GREGORY CANYON LANDFILL

- Peer Review of Technical Studies, Geosyntec Consultants, August 10, 2012, Revised October 12, 2012 and November 28, 2012

Date: 10 August 2012, Revised 12 October and 28 November 2012
To: William Miller, U.S. Army Corps of Engineers, Senior Project Manager
From: Jennifer Nevius, P.E. and Shana McCarthy
Subject: Peer Review of Technical Studies
Gregory Canyon Landfill

RE: **RESPONSE TO GEOSYNTEC COMMENTS FOR THE ARMY CORPS PERMIT
GREGORY CANYON LANDFILL
SAN DIEGO COUNTY, CALIFORNIA**

Figure 1 –PreNGA vs. NGA Site Response Curves (Adopted from: EERI Webinar, December 14, 2011: Shear-wave Velocity Profiling and Its Importance to Seismic Design, Jared West, Purdue University, Host)

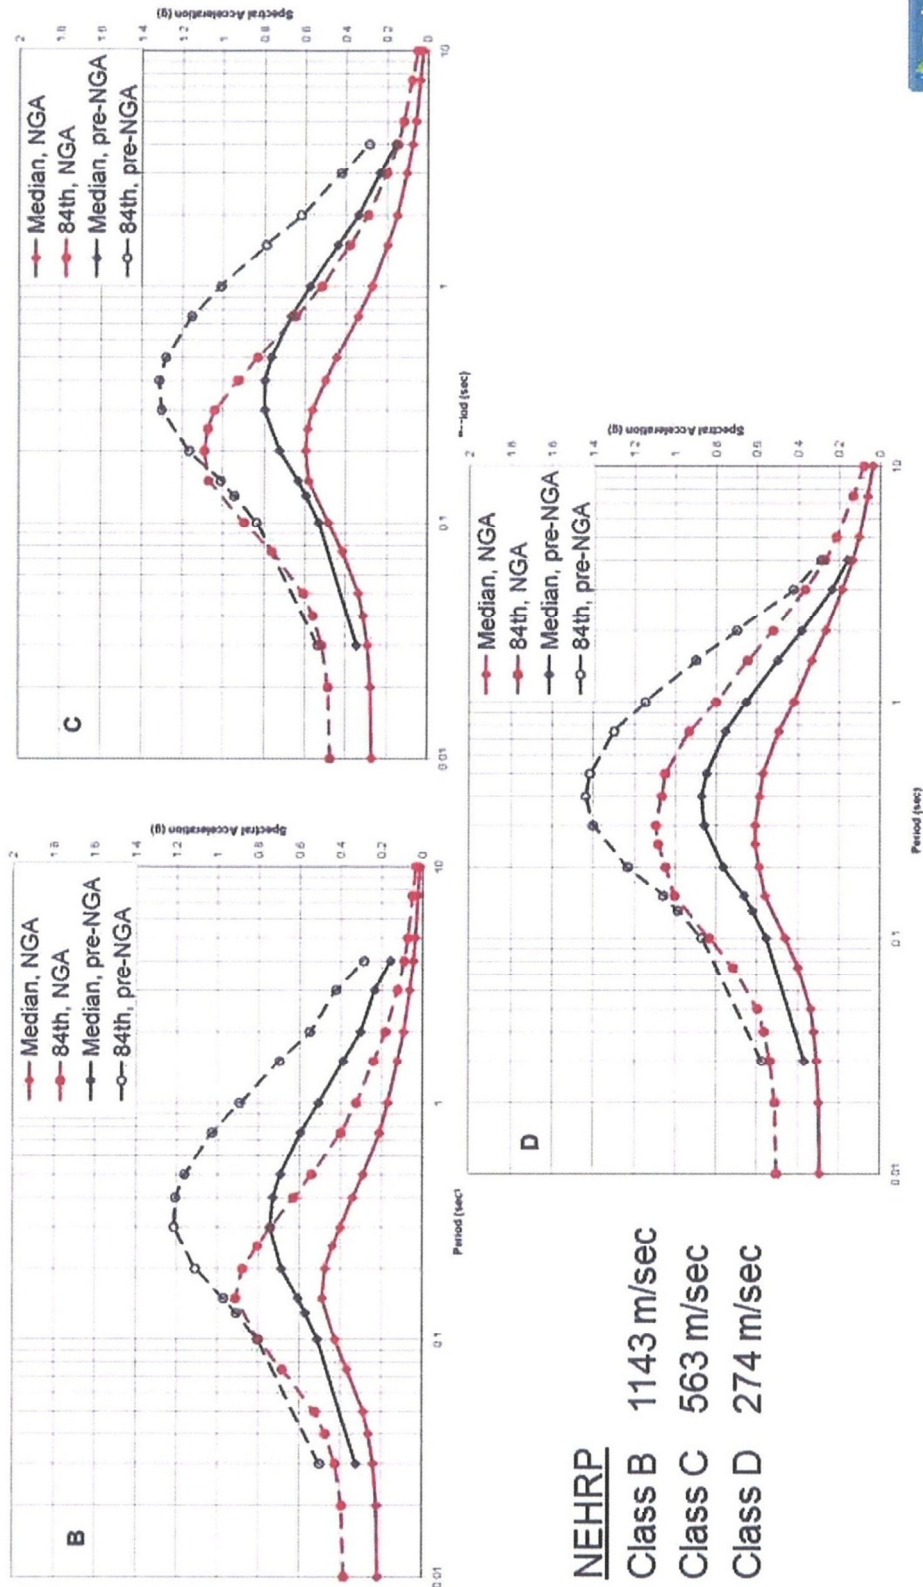
Comment No. 3: Review of potential effect of advances in the state of the practice on seismic design (e.g. NGA attenuation models).

Response to Comment No. 3: Based on review of the State of California Fault maps (CGS, 2010) and the California Seismic Hazard Maps (Cao, et. al., 2003), no new geologic data has been released that will significantly alter the seismic hazard analysis performed for the Gregory Canyon Landfill to date. With respect to recent attenuation relationships (specifically the NGA attenuation relationships and others), it is well understood that use of the newer NGA attenuation relationships will result in a lower site acceleration than the older attenuation relationships used to generate the design site acceleration for the Gregory Canyon Landfill (a typical comparison is presented in Figure 1).

By: JGF Date: 5-23-2012 Subject: Gregory Canyon LF Sheet No. 1 of 1
Chkd. by: _____ Date: _____ Cover Slope Stability Analysis- Infinite Slope PN. 95-039/089

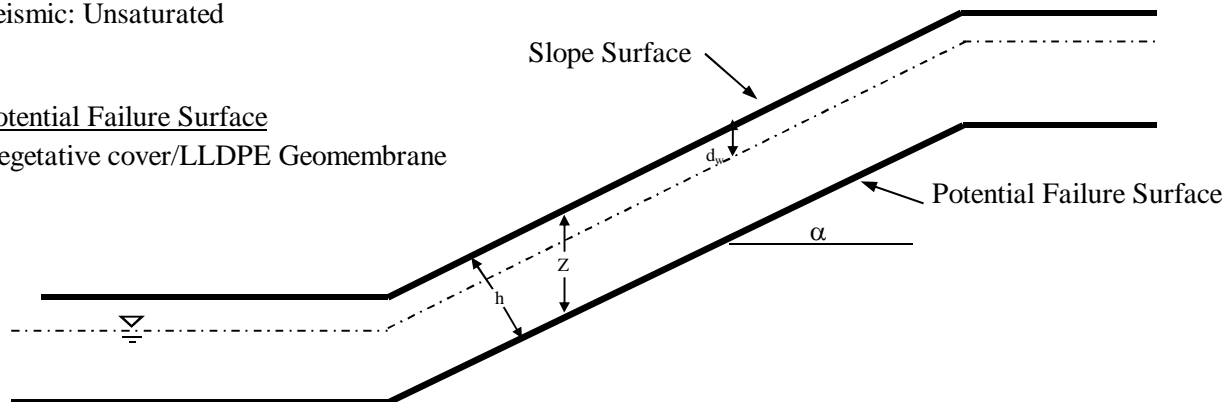
Comment No. 4: Review of material parameters utilized for the final cover/geomembrane interface used for the slope stability and seismic deformation analyses. Was a seepage condition evaluated?

Response to Comment No. 4: At the time the original cover stability calculations were performed (GLA, 1999), an extensive database of interface shear strength parameters for the textured LLDPE/soil cover interface was not readily available. Accordingly, the initial cover stability analysis was performed assuming the minimum interface shear strength parameters (friction angle of 27 degrees and a zero cohesion value) to achieve a factor of safety of 1.5 for the non-saturated, static case. A fully- or partially-saturated slope (seepage) condition was not originally evaluated for cover stability.
